TECHNICAL BULLETIN INDEX
Sorted by Bulletin Number
06/25/86

DATE: January 10, 1983
REVISION DATE: January 10, 1983
BULLETIN NO.: 12/16B:1
PRODUCT: 26-4004/5 (Model 12)
SUBASSEMBLY: Motorola Video Board

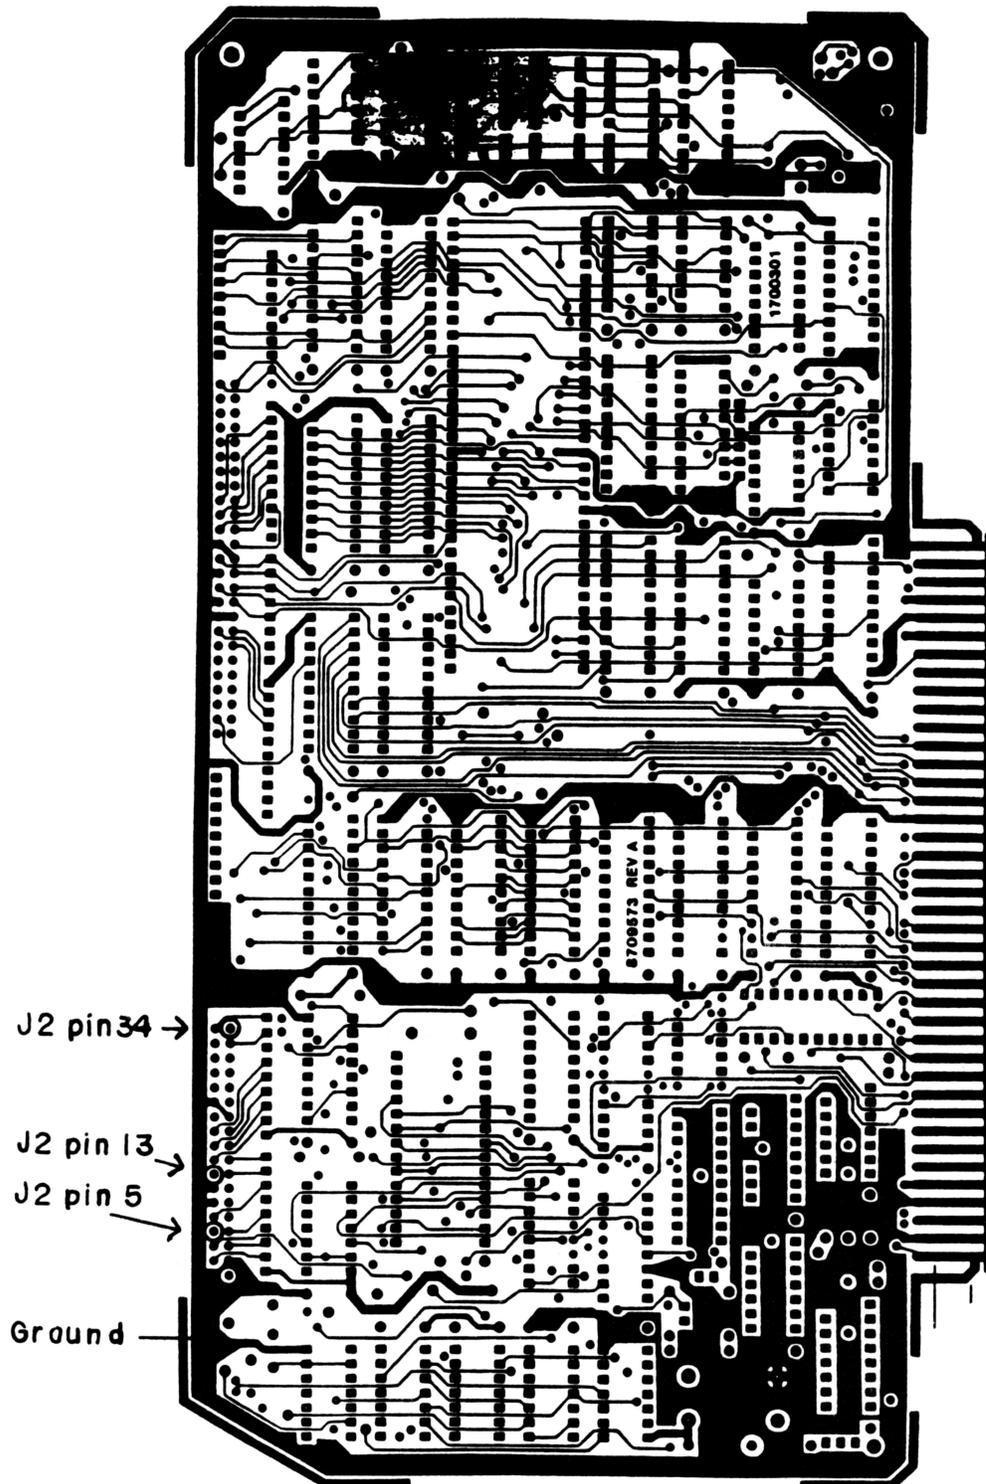
Due to an error in the artwork on early revision (Revision A) boards, a modification to insure good ground connections between the 68000 CPU board and associated memory boards is required.

Ground may be found at the feed-throughs on the ground plane near J2 on the solder side on the board.

Figure 1

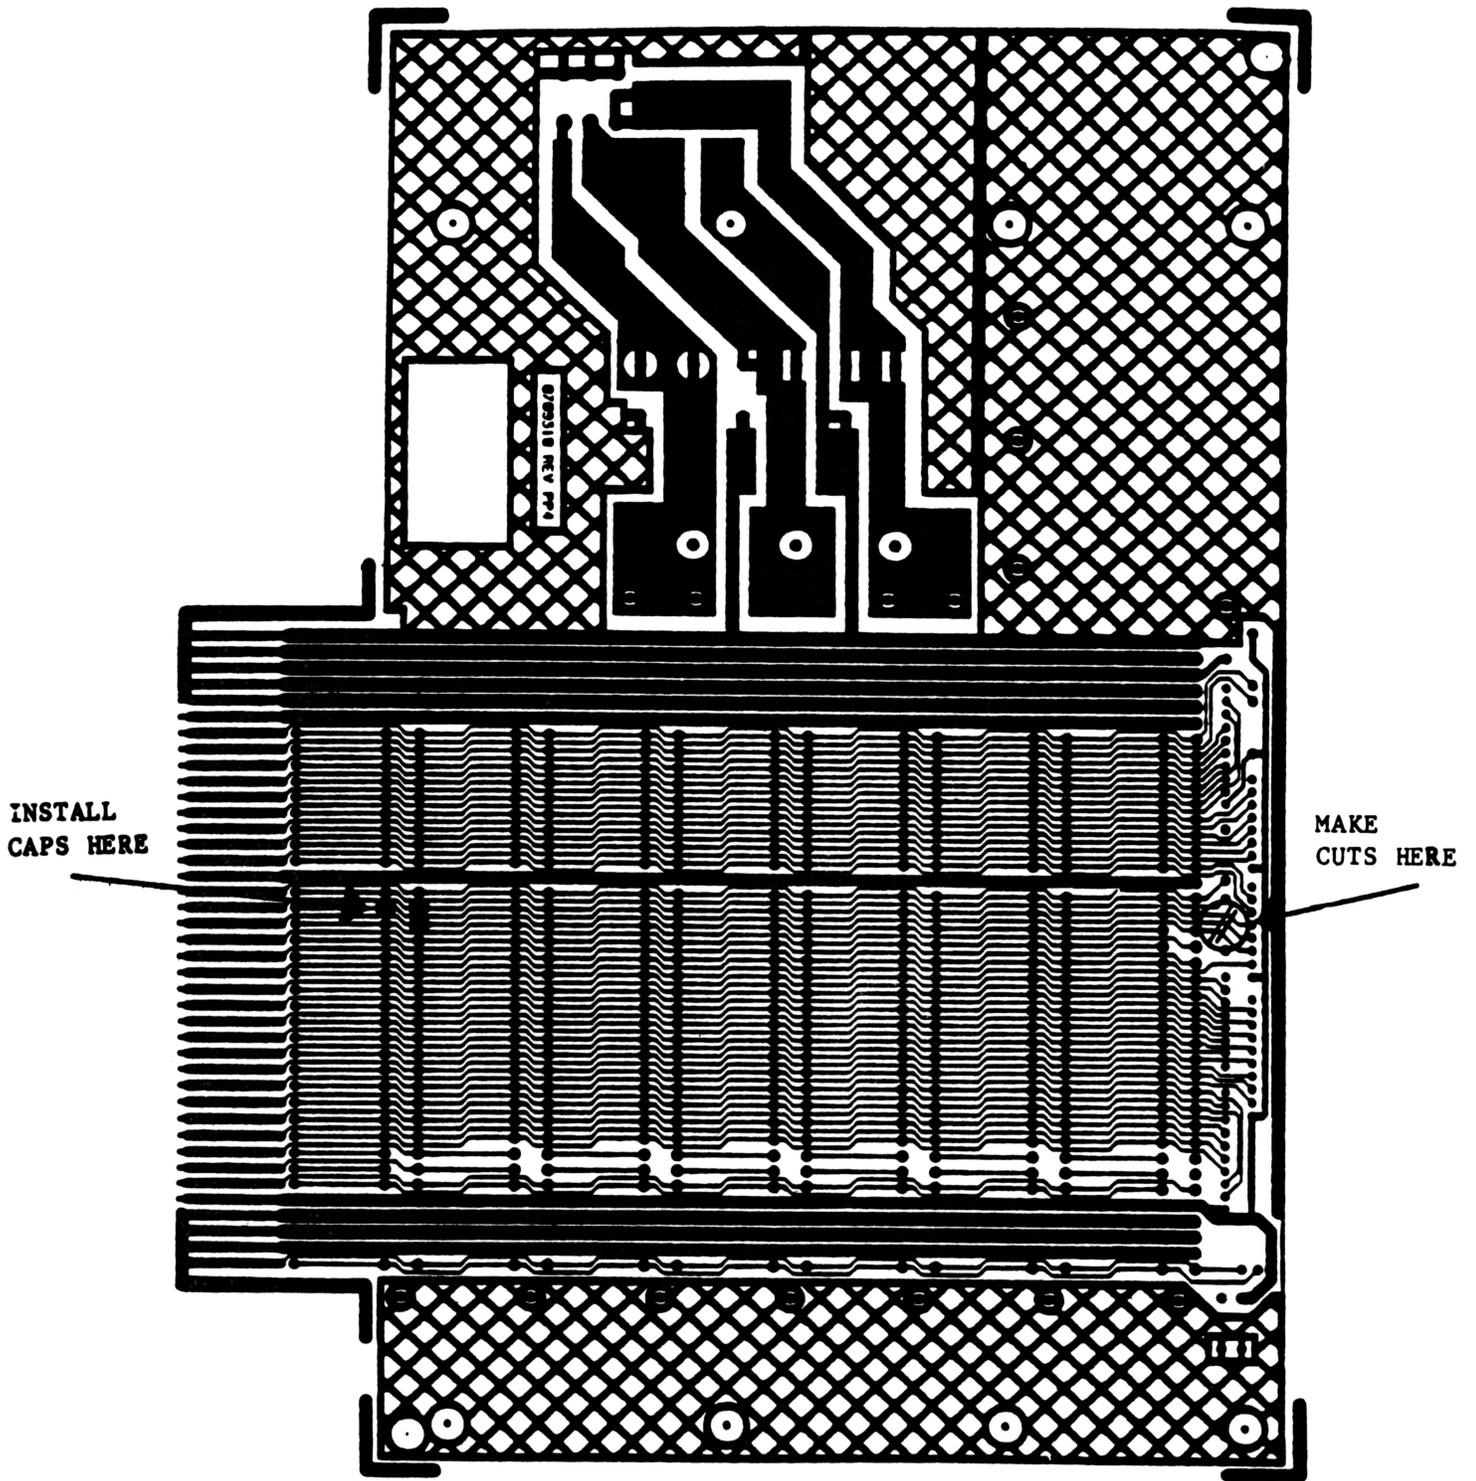
On mother boards of revision levels prior to Rev. B, pins 3, 4, and 5 on resistor pack R6 need to be cut.

On mother boards of revision level Rev. B or later, pins 4, 5, and 6 on resistor pack R6 need to be cut.

On boards of all revision levels, three (3) 220 pf caps should be jumpered from pins 44, 45, and 46 to ground on the bottom-most connector. These pins correspond to the traces cut on the resistor pack R6. See Figure 1 for clarification. The capacitors needed for this modification may be ordered as:
